Information Only
Service Note

Supersedes:
E5063A-09A

E5063A ENA Series Network Analyzer

The Situation – New Touch Panel & Touch Panel Controller Available with LF Updates and Digital Interface Option

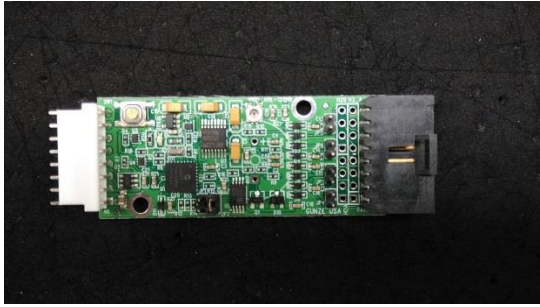
4. When CPU is found to be defective:
   - For defective Kontron CPU, replace it with Kontron CPU (E5061-62180).
   - For defective Argo CPU, replace it with Argo CPU (E5063-65053). Note that repair for CPU-FAN is not allowed for Argo CPU.
